# EO 30-001 Relocation of Wiper Switch

EC135 T3H/P3H

Fig. 1 – Relocation of wiper switch on PIC Collective Lever

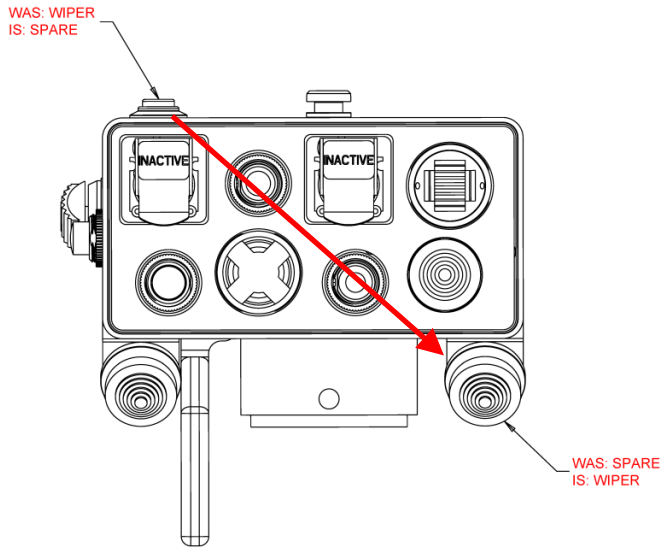
With this modification, the wiper switch on the PIC collective lever is relocated as shown in Fig. 1. This reduces the risk of an unintended activation of the windscreen wiper when the collective lever is fixed with its locking lug, as unintended activation in dry conditions causes scratches in the windscreen. The actual function and activation of the wiper is not changed. Pushing the 4-way toggle switch once in any position/direction causes one cycle of the windscreen wiper. The new switch is labelled for its intended function.
